PHP – Technical Bulletin

Bulletin Number: 210201

Subject: PH20A and PH40A Main Wiring Connections

Scope: PH20A and PH40A Heaters

Open End View Of Main Heater Harness Connector (Harness Side)

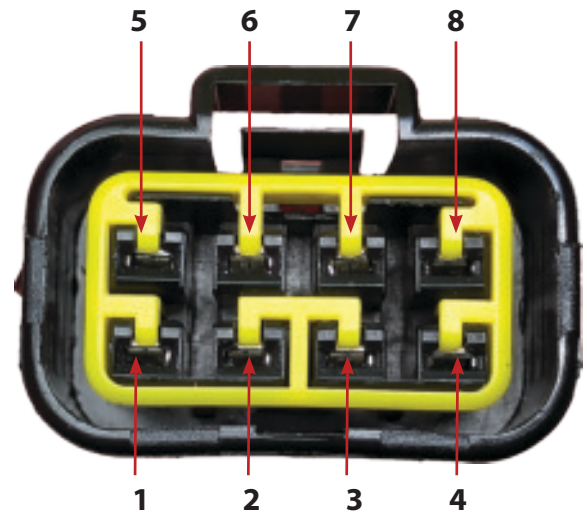
Original manuals have incorrect wiring diagram.

The following diagram shows the correct wiring connections for the main harness.

Terminal	Wire Color	Function
1.	White	Switch
2.	Blue	Switch
3.	Yellow	Fuel Pump
4.	Red / White	Main Power “+”
5.	Red	Switch
6.	Green	Switch
7.	Yellow	Fuel Pump
8.	Black / White	Main Power “-”
